ZONING CHANGE REVIEW SHEET

CASE: C814-97-0002.01
(Mary Vice Estates PUD Lot 27 Amendment #1)

Mary Vice Estates PUD Lot 27 Amendment

MARY VICE ESTATES AUSTIN HABITAT FOR HUMANITY P.U.D. LAND USE PLAN

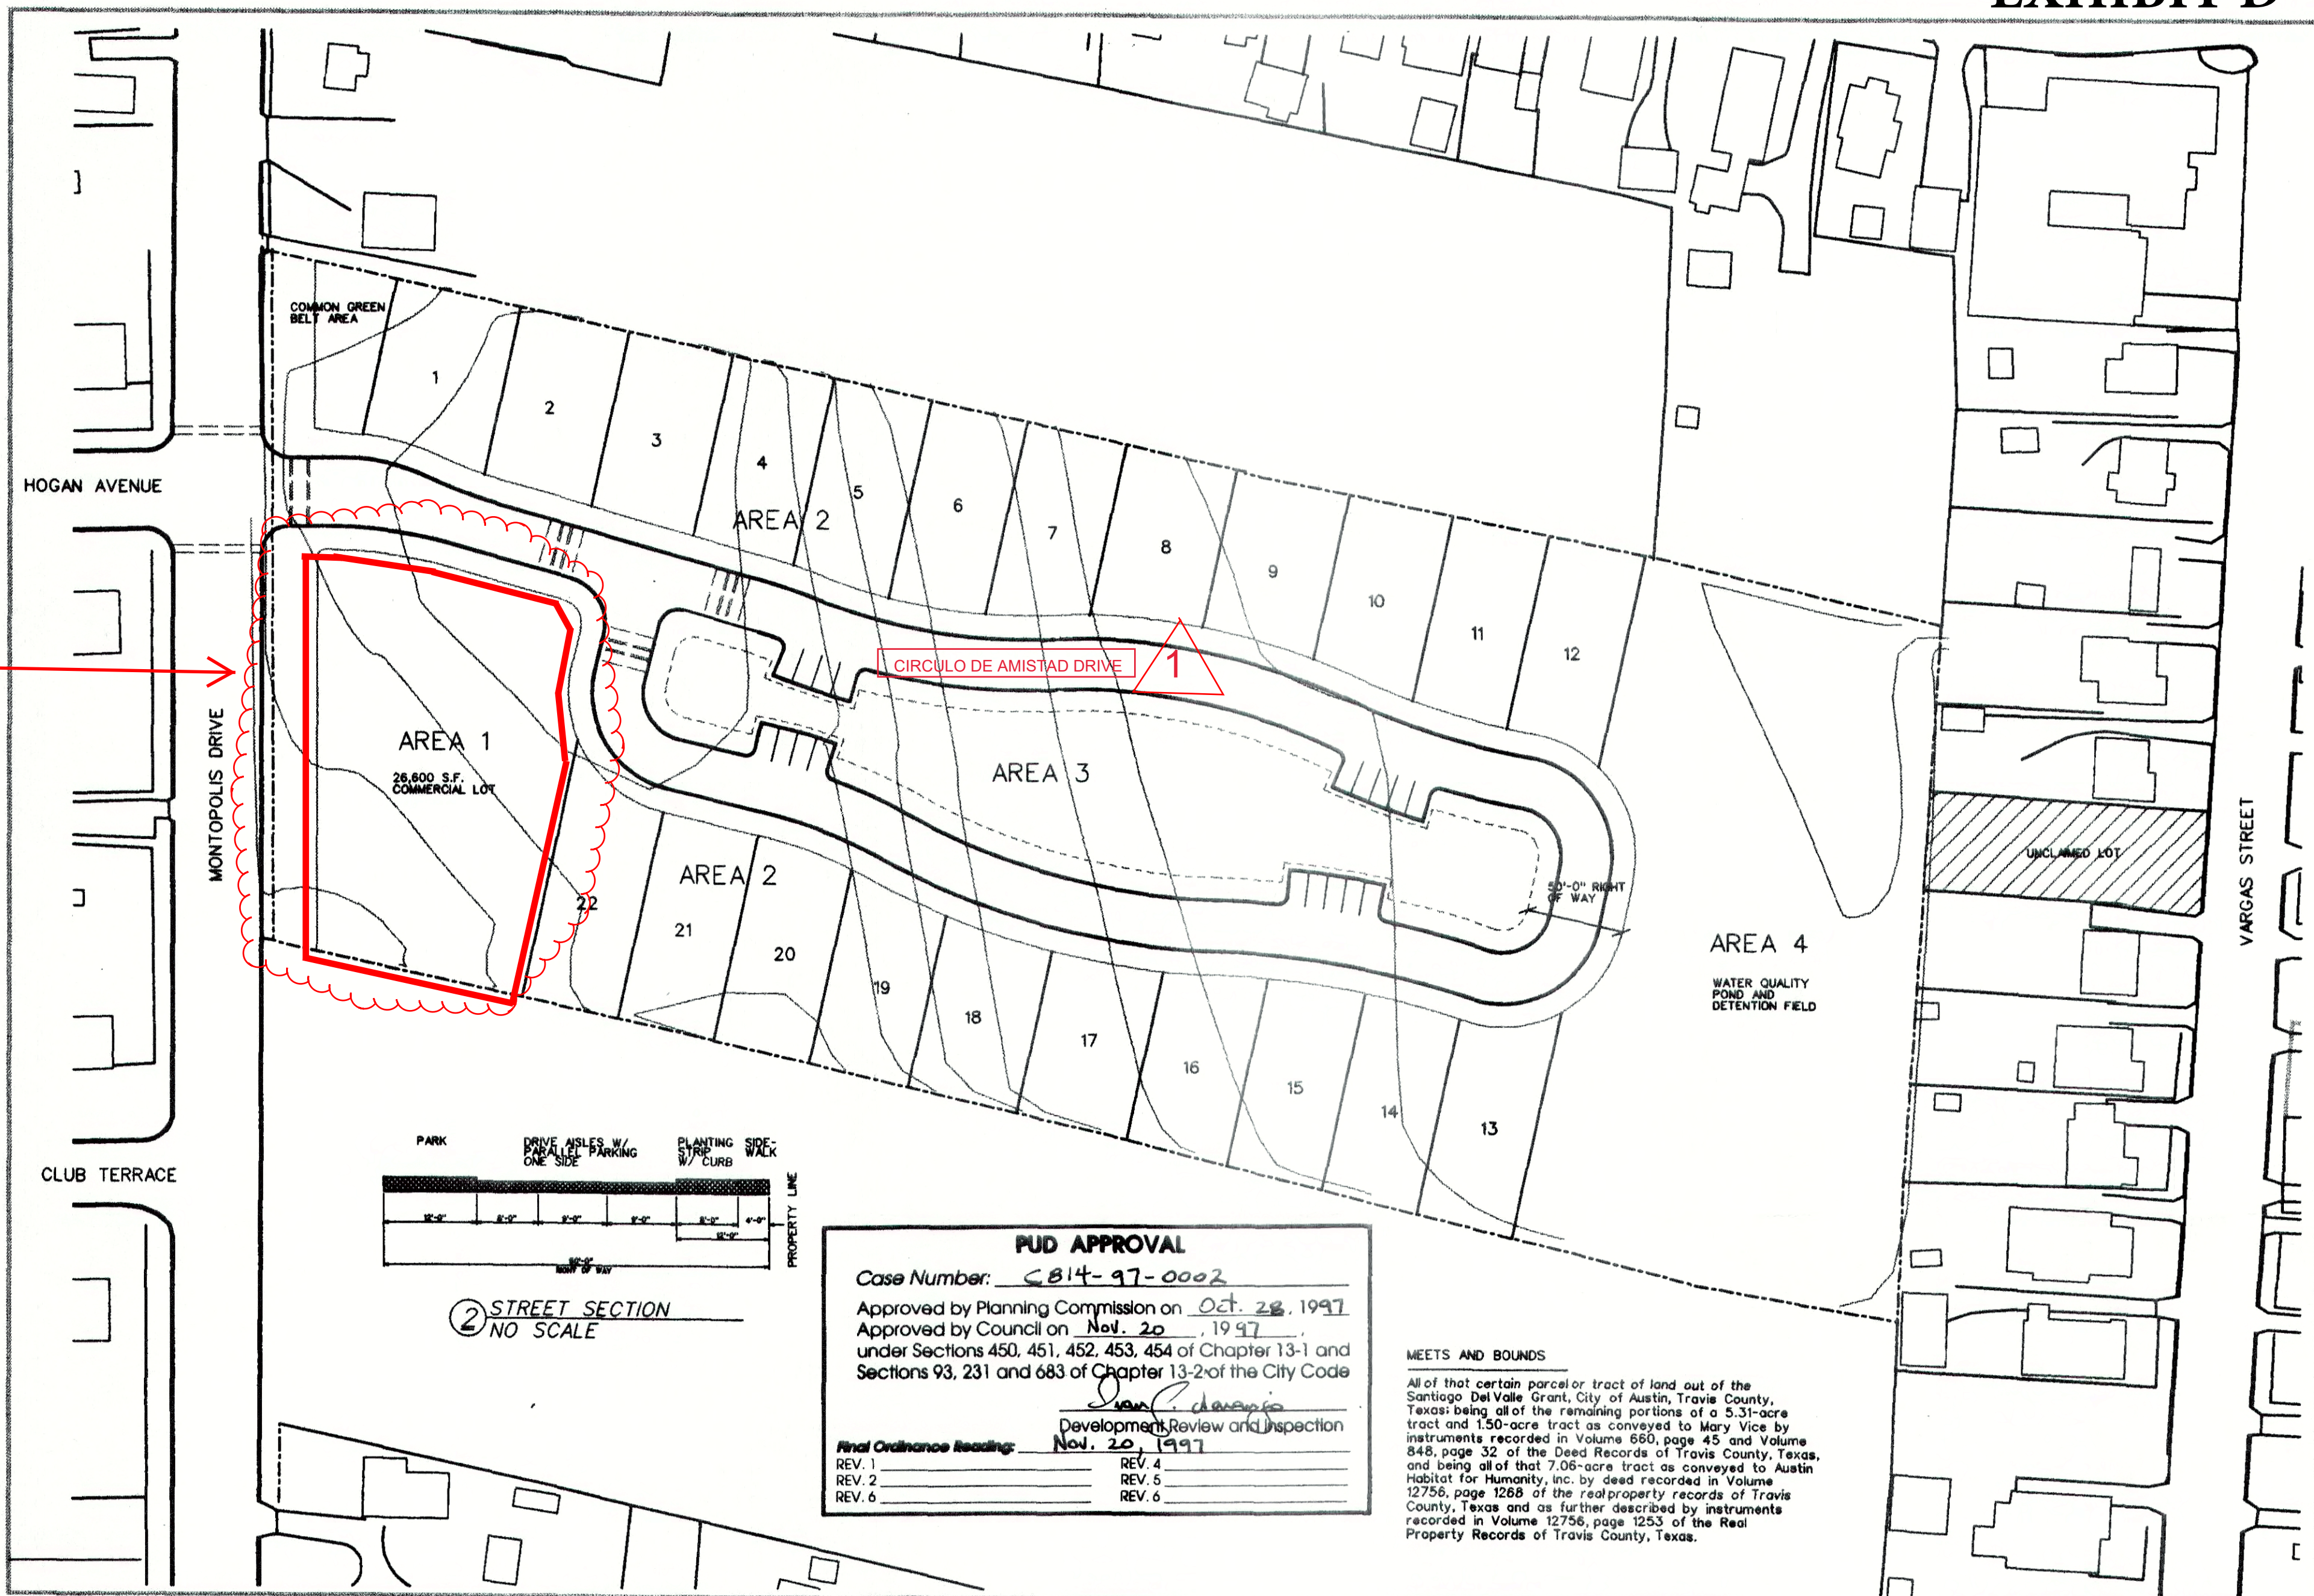
The original note 13 specifies that approximately 1 acre of parkland was dedicated as part of this development; it is unclear how or where the dedication and satisfaction of parkland requirements have been met for the existing development. Please provide documentation that parkland dedication has been satisfied for the PUD, barring this amendment.

If documentation can be provided that parkland dedication was satisfied as described in the existing note 13, then revise note 28 to the following:

Delete the applicant's proposed note 13 and replace with note 28.

Remove notes 8 under both general notes and additional site regulations. Development should comply with current City regulations for parking and loading.

Revise note 18 regarding access. All access to the development should be limited to public loop road. No access should be permitted to Montopolis Drive.

Sidewalks on Montopolis shall be constructed following Subchapter E design guidelines. Please add note to Exhibit.

Note 20 states that a pedestrian and bicycle connection to Vargas Street is intended if the owner obtains the adjoining lot. Has this lot been purchased? If so, the connection should be shown as required.

Parkland dedication has been satisfied for 24 single family units with the dedication of 1 acre of parkland. Any increase in units will be subject to Land Development Code Section 25-1-601, as amended, for all property within the PUD.
